NOTICE OF DECISION
 Columbia Precast – Site Plan Review

Land Use Application Nos.:	SPR 21-003 (Site Plan Review) SEP 21-003 (SEPA)
Applicant:	Jason Miles, Columbia Precast Products
Property Owner:	Gar & Hatt Woodland
Site Location:	1765 Howard Way, Woodland
Parcel:	508301010
Zoning Designation:	Light Industrial (I-1)
Date Application Received:	May 8, 2021
Notice of Application & Likely DNS issued:	June 8, 2021
Comment Period & SEPA Appeal Period Ended:	June 30, 2021
Notice of Decision Issued:	July 21, 2021
DRC Decision:	Approve with Conditions

Attachment A
Site Plan

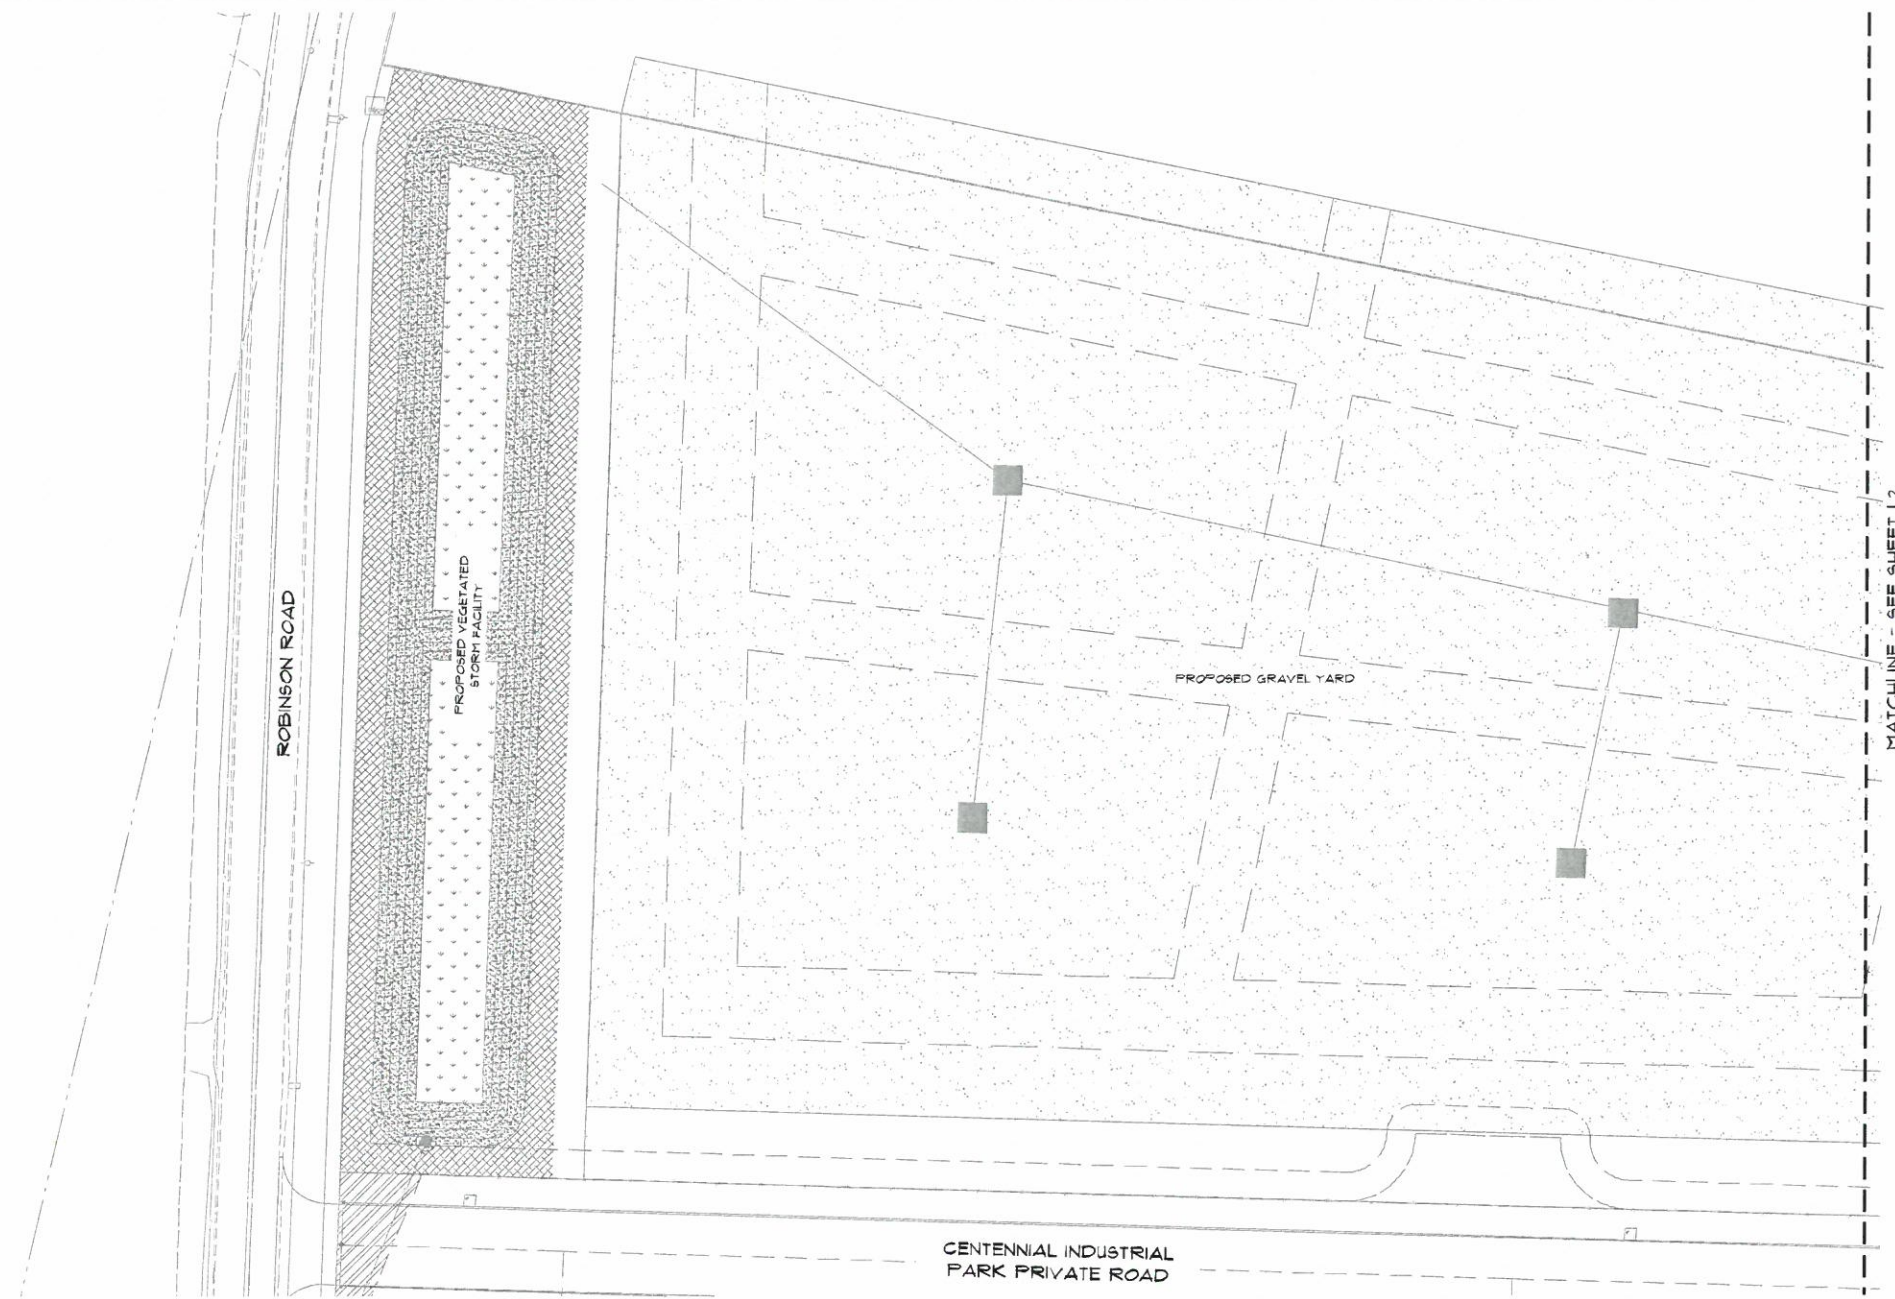
Finding 9: A preliminary erosion control plan was submitted as part of the preliminary site plan submittal. The plan shows use of sediment fencing and inlet protection. It appears that at minimum additional sediment fencing on the north side of the site and a construction entrance will be needed in order to comply with City standards. The disturbed area shown on the plan is more than one acre, thus coverage under the statewide NPDES permit will be required. A condition of approval is added to meet all erosion control requirements of WMC 15.10 and follow the Woodland Design Standards for the erosion control plan. *See Condition #2.*

Finding 11: It is noted on the preliminary plans that groundwater has previously been encountered in the immediate area at elevation 14.56 feet, which is above the proposed bottom elevation of the combination detention/wet pond of 14 feet. The storm design will need to consider the issue of high groundwater in the area, and the issue should be addressed in the TIR. Pond lining or other measures may be necessary to address this issue. *See Condition #4.*

Finding 44: Storage areas and plans for screening along the public road are not shown on the site plan. A condition is added to show on the site plan and address in the narrative how landscaping and screening will be used along public streets for all proposed outdoor storage areas to meet the requirements of WMC 17.44.136 (G). *See Condition #11.*

2. Meet all erosion control requirements of WMC 15.10 and follow the Woodland Design Standards for the erosion control plan.
3. A Final Stormwater Technical Information Report (TIR) conforming to the requirements of WMC 15.12.180 must be submitted with final engineering.

4. The storm design will need to consider the issue of high groundwater in the area, and the issue should be addressed in the TIR. Pond lining or other measures may be necessary to address this issue.

11. Show on the site plan and address in the narrative how landscaping and screening will be used along public streets for all proposed outdoor storage areas to meet the requirements of WMC 17.44.136 (G).
